| Doc. No.: X3T10/96-227r0 |

Project: 1142-D

Subject: Minutes of SPI-2 Working Group
August 13-14, 1996 -- Milpitas, CA

HOT PLUGGING CONNECTOR ARCHITECTURE THAT ELIMINATES THE ELECTRICAL DISTURBANCE CAUSED BY A METAL TO METAL FIRST CONTACT

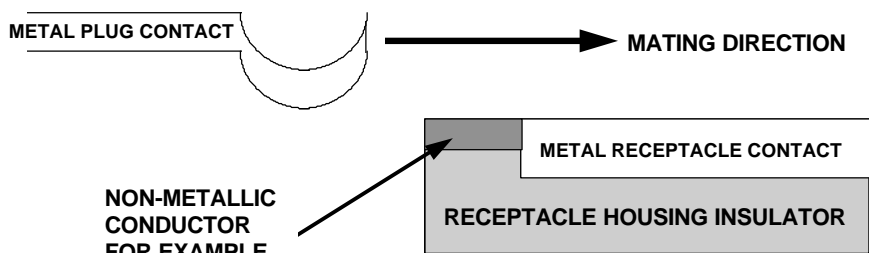
Bill Ham noted that the section in SPI-2 that deals with hot plugging needs more work. We need to clarify that plugging LVD devices into a live LVD bus may result in signal errors, but will not cause physical damage to the devices. Notes also need to be added regarding HVD, LVD, and SE mixing.

If the connector contact design can be modified to have a lead-in area with high-impedance followed by a normal low-impedance contact, then Case 4 hot-plugging can be supported (should this be called Case 5?). Some of the connector people are looking into this issue. We need to make sure that all of the connector people are aware of this need.

PLUG CONTACT MAKES FIRST CONTACT WITH THE NON-METALLIC CONDUCTOR AND ALLOWS THE VOLTAGE TO EQUALIZE BETWEEN THE PLUG CONTACT AND THE RECEPTACLE CONTACT BEFORE A METAL TO METAL CONTACT HAPPENS -- THIS COULD BE USED ON THE SIGNAL PINS FOR SCSI DEVICES FOR EXAMPLE WHERE NO CURRENT FLOWS AFTER THE CAPACITANCE IS CHARGED ON THE CONTACTS

THE SERVICE POSITION IS METAL TO METAL

NON-METALLIC CONDUCTOR FOR EXAMPLE CARBON IMPREGNATED PLASTIC

NOTE THAT THE NON-METALLIC CONDUCTOR IS ELECTRICALLY CONNECTED TO THE RECEPTACLE CONTACT

THE DESIGN CONCEPT SHOWN IS THE SAME AS THE SCA-2 WITH THE TOP PART OF THE HOUSING INSULATOR REPLACED WITH A NON-METALLIC REGION
